2.2 STRUCTURAL AND SYSTEMS ENGINEERING

2.2.1 Building Structures Design Description

2.2.1.1 Reactor Building (R/B)

Figure 2.2-1 US-APWR Building Configuration (Plan View)

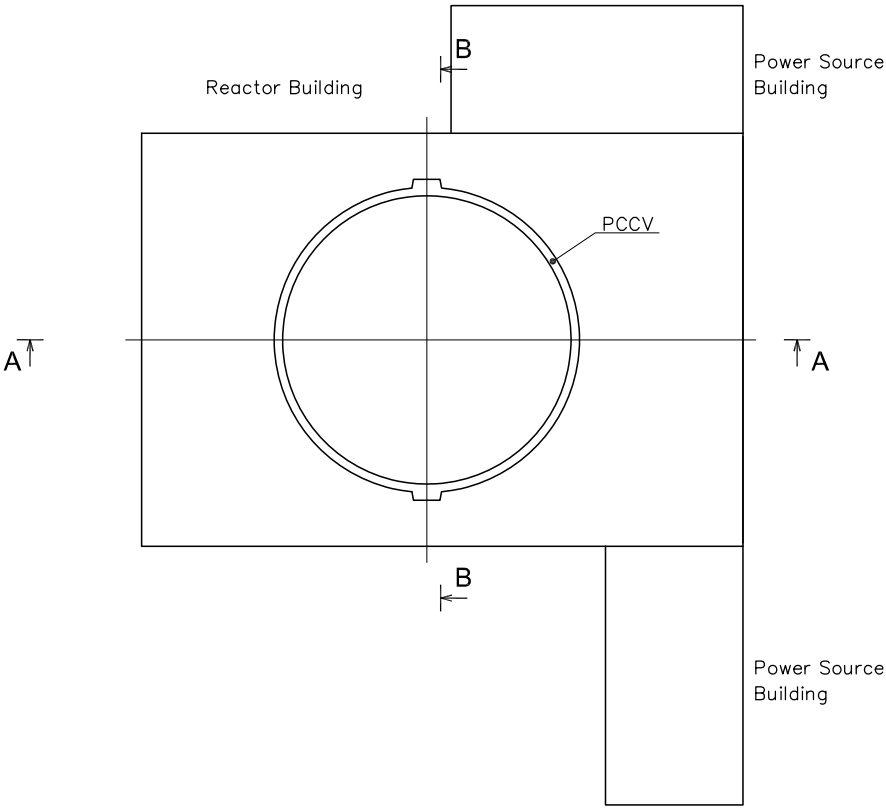
MIC-03-T1-0
0005

Figure 2.2-2 US-APWR Building Configuration (Section Views)

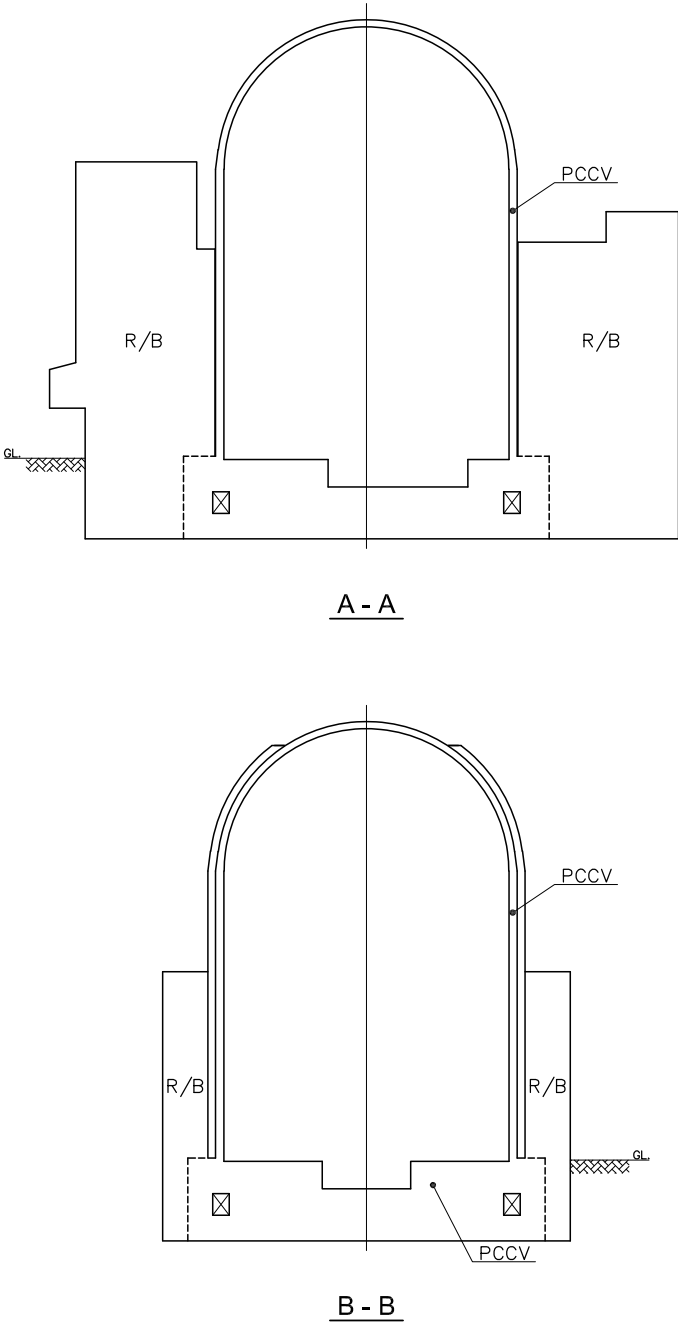
MIC-03-T1-0
0005
